Subject: Transmittal of Revision 1 To Service Bulletin Number
V25000-ENG-72-0321

ENGINE - HP TURBINE ROTOR AND STATOR ASSEMBLY - INTRODUCE NEW FIRST AND SECOND
STAGE TURBINE BLADES WITH UNDER PLATFORM COATING

MODEL APPLICATION

V2500-A1

Modification of the Stage 2 High Pressure Turbine Blade Assembly
Figure 4 (Sheet 1)

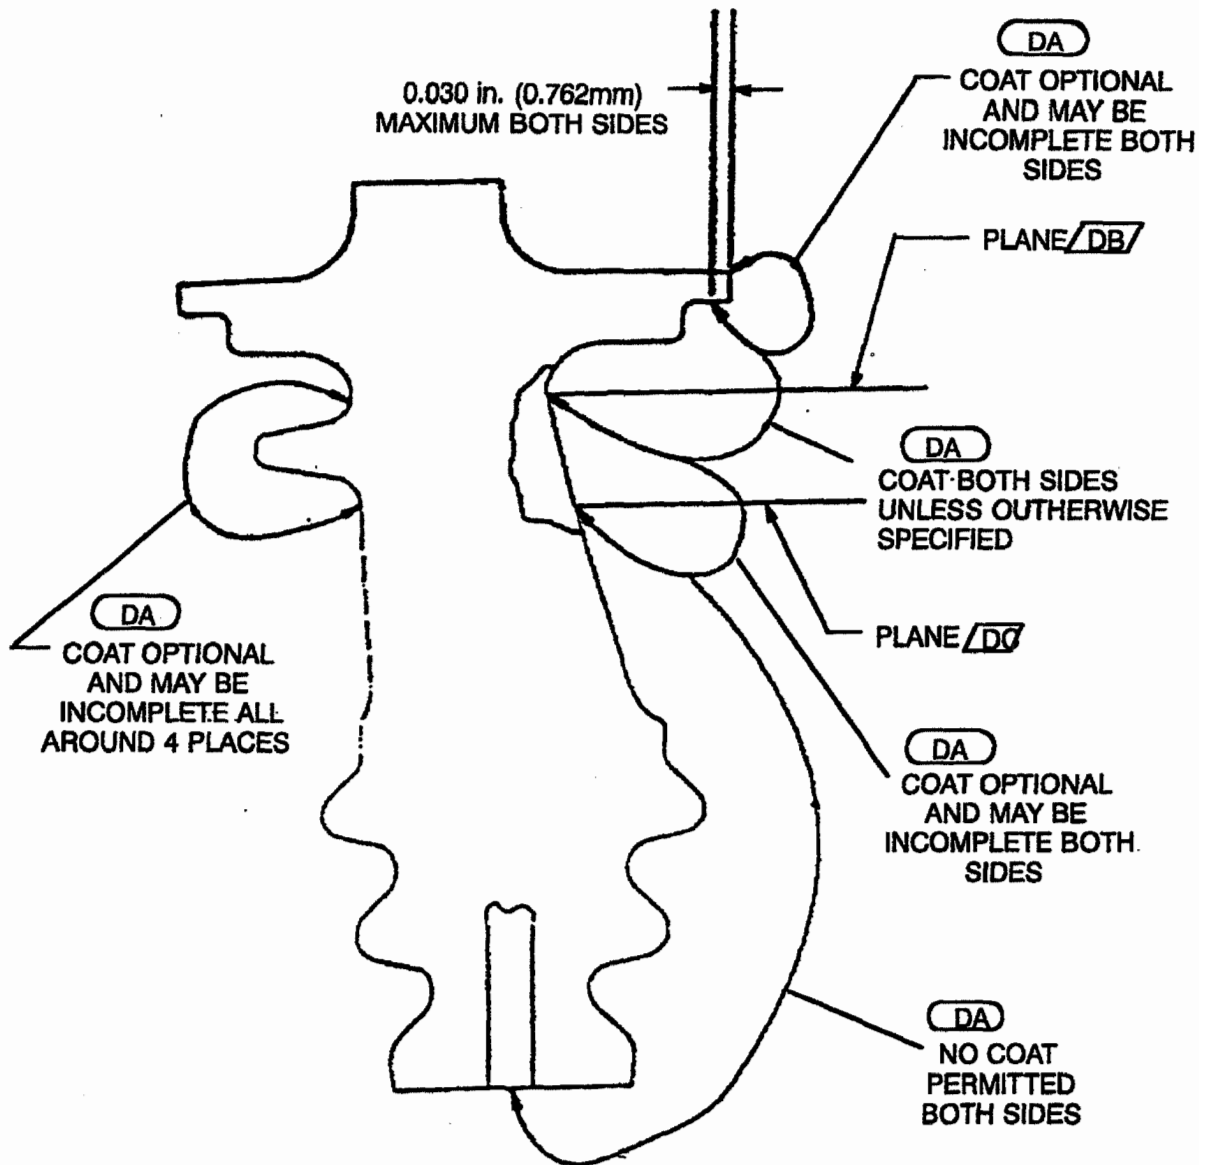
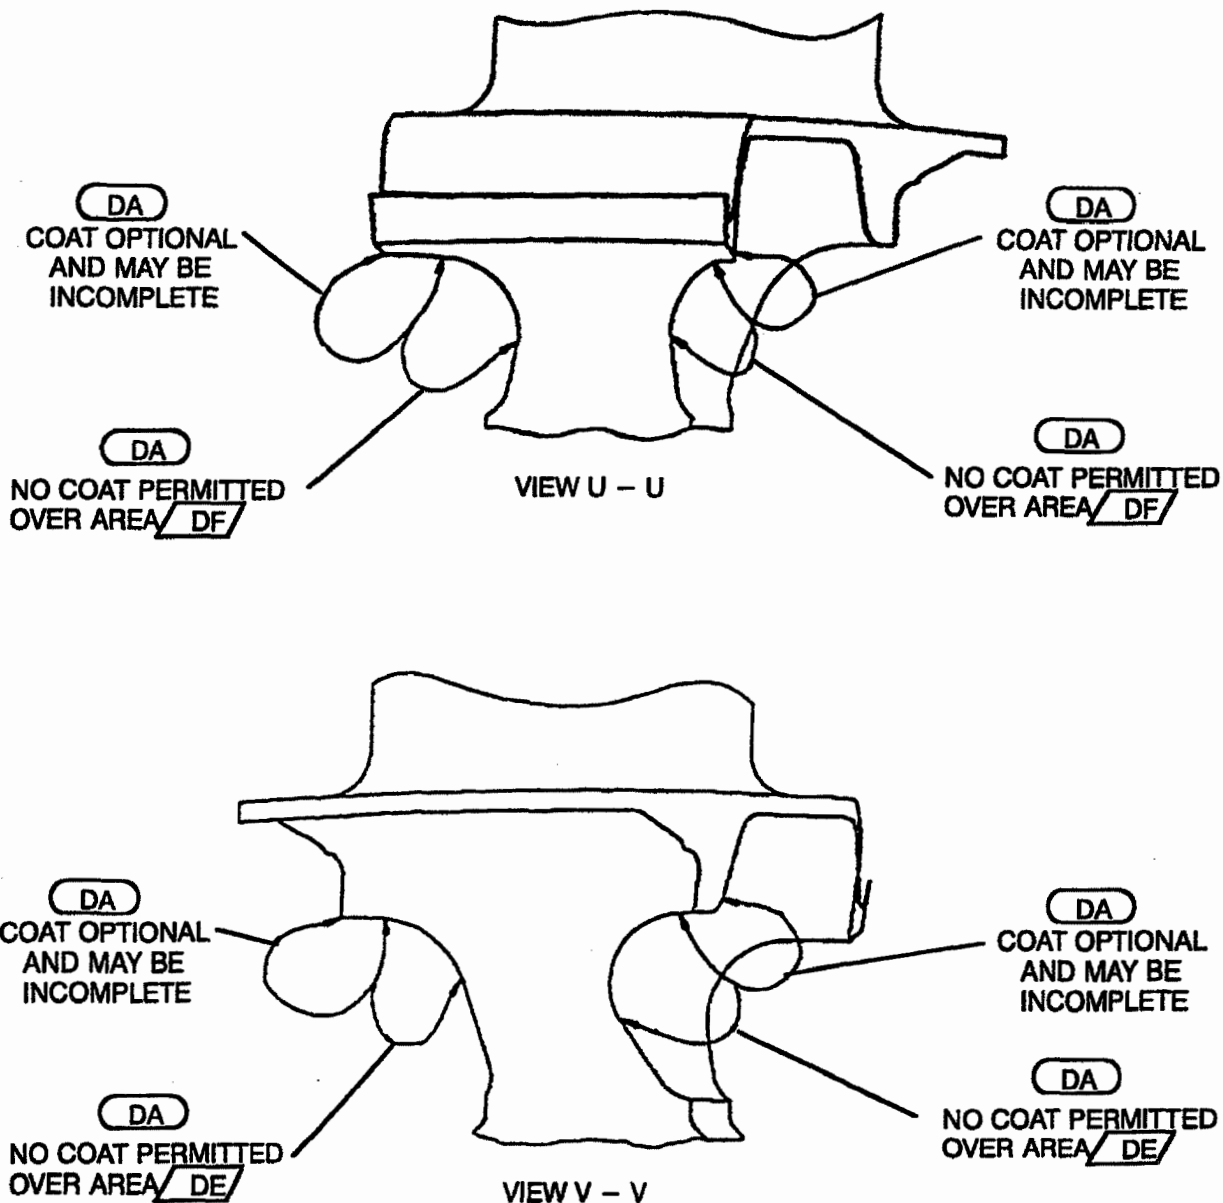
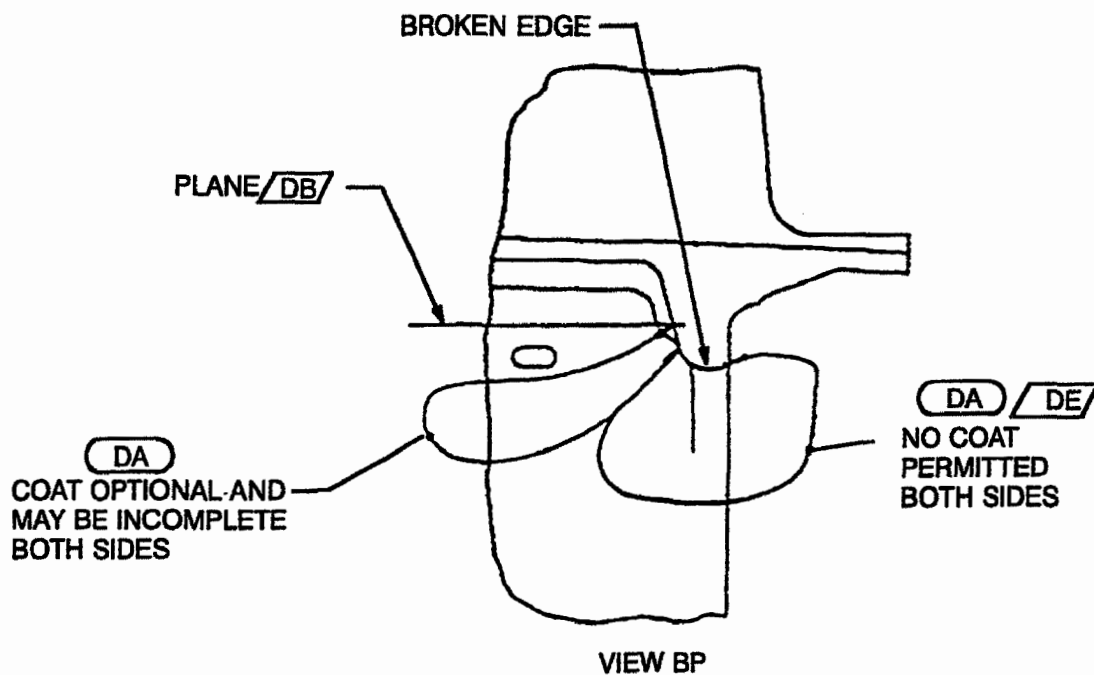
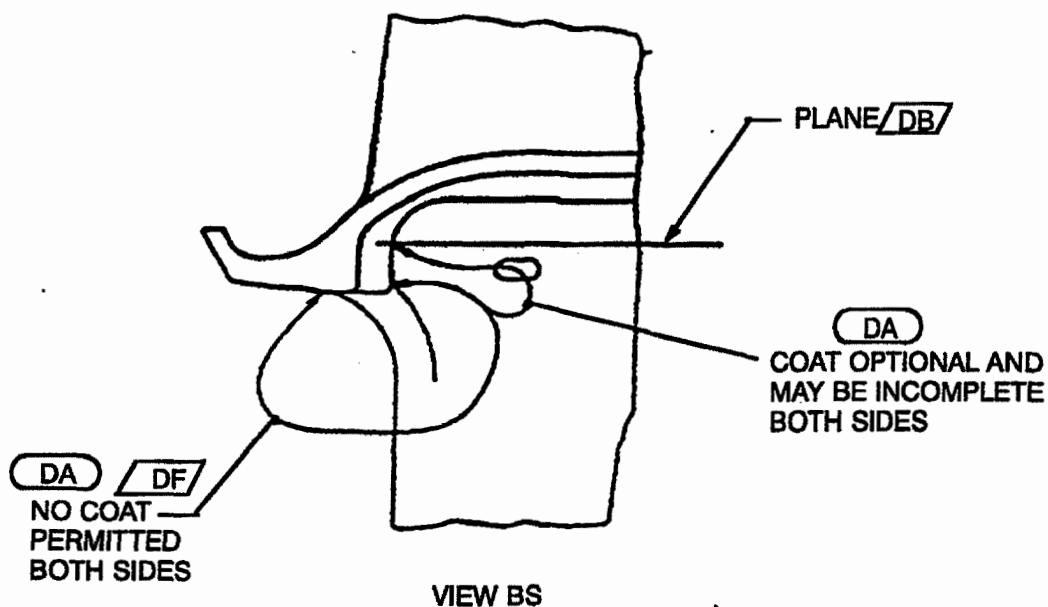
| (i) | Apply protective coat to the blade under platform area by the procedure specified. | Refer to Reference (3), Chapter/Section 70-38-26, Surface Treating. See Figure 4. |

| (j) Do a check of the under platform area for the presence of coating by the procedure specified. | Refer to Reference (3), Chapter/Section 70-28-01. See Figure 4. |
| (k) Touch-up under platform areas that have insufficient coating by the procedure specified. | Refer to Reference (3), Chapter/Section 70-38-26. See Figure 4. |

1 The cooling rate must be 10° F/minutes minimum average to 1200° F and cooling at any convenient rate thereafter. | Refer to Reference (3), Chapter/Section 70-37-03 Heat Treating. See Figure 4. |

1 The cooling rate must be 10° F/minutes minimum average to 1200° F (648.9° C) and cooling at any convenient rate thereafter. | Refer to Reference (3), Chapter/Section 70-37-03, Heat Treating. See Figure 4. |

DA COAT IN THE APPLICABLE AREA BY THE PROCEDURE SPECIFIED IN THE TEXT

Family Tree - Stage 1 High Pressure Turbine Blades
Ref. Catalog Sequence No 72-45-14. Fig. 01 Item 010
Figure 5 (Sheet 1)

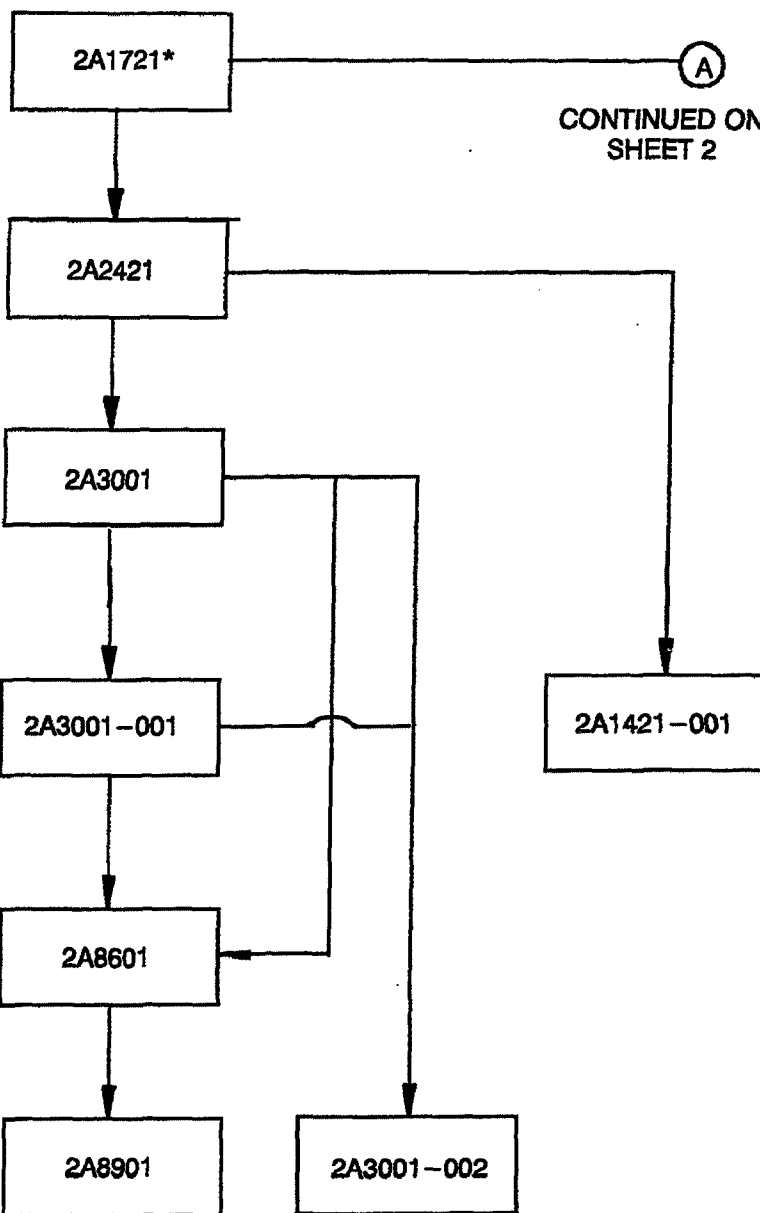
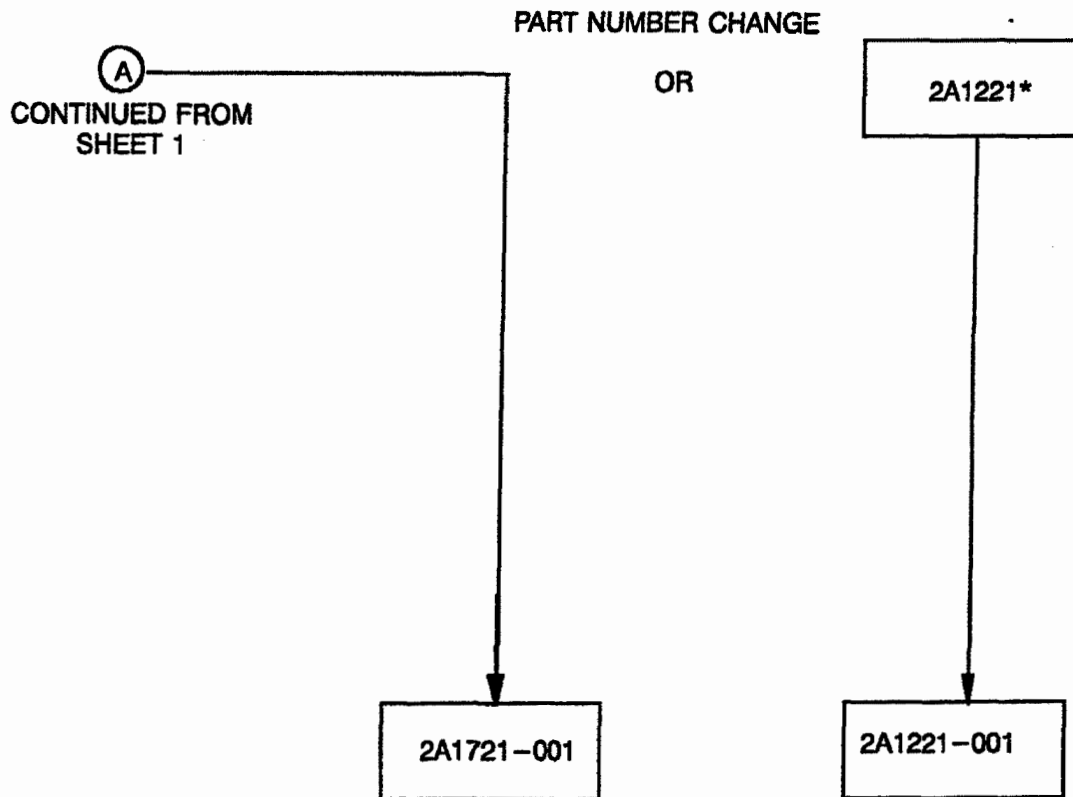
V2500-ENG-72-0321
ENGINE - HP TURBINE ROTOR AND
STATOR ASSEMBLY - INTRODUCE
NEW FIRST AND SECOND STAGE
TURBINE BLADES UNDER PLATFORM
COATING

Family Tree - Stage 2 High Pressure Turbine Blades
Ref. Catalog Sequence No 72-45-32. Fig. 01 Item 010
Figure 6

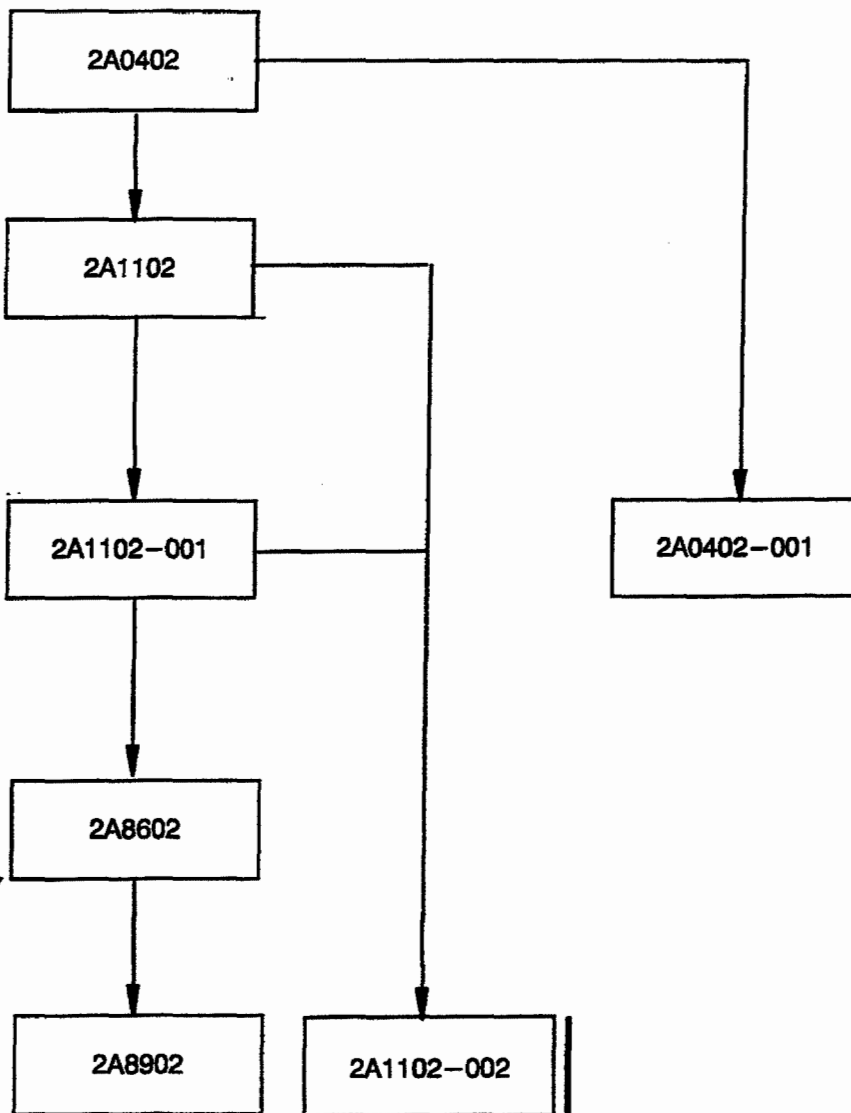
V2500-ENG-72-0321
ENGINE - HP TURBINE
ROTOR AND STATOR
ASSEMBLY - INTRODUCE NEW
FIRST AND SECOND STAGE
TURBINE BLADES WITH UNDER
PLATFORM COATING
